**OBJECTION TO APPROVAL OF DA 2021/0318  
FOR CONSIDERATION BY NB LOCAL PLANNING PANEL ON 21 JULY 2021**

VIEW FROM Ground floor G01 # 46

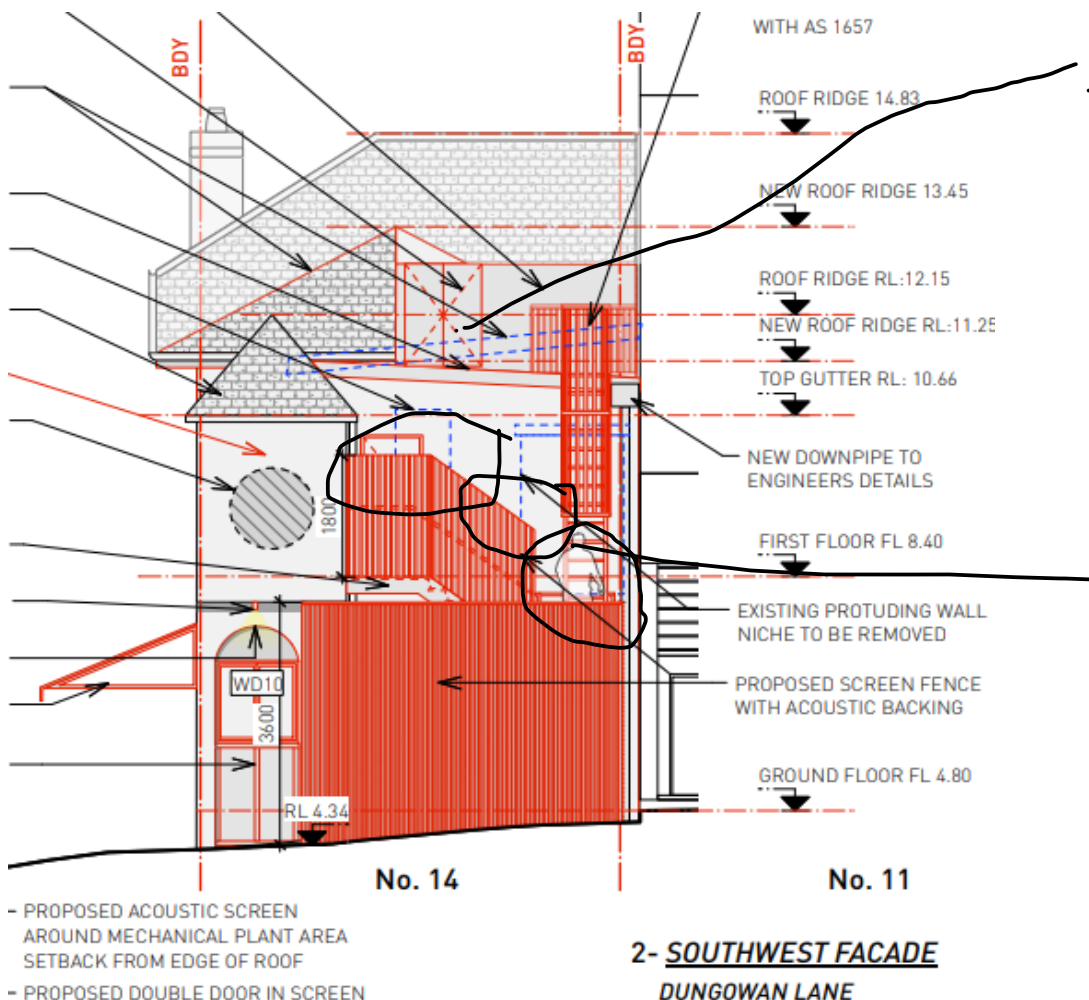
1. Significant light/ sound and movement amenity loss which will project into more than 5 ocean adjacent balconies, 11 bedrooms, 5 kitchens, 5 living areas. This extract from the applicants drawings is at ground level, as you go up levels in #46 Victoria Parade the visibility into the stairwell and kitchen door worsens... the drawings show the clear vision of staff/ delivery people moving up and down the stairwell and the proposed screen is completely inadequate in screening vision into the busiest part of the kitchen.

Insufficient detail on plant screening, does it or does it not cover the mechanical plant

The screen does not adequately cover sound, movement and light of activity on the stairwell... YOU CAN SEE STRAIGHT INTO THE KITCHEN... We will be exposed to all movement from the kitchen to the bottom of the stairs... THIS IS 4 METRES FROM OUR PROPERTY
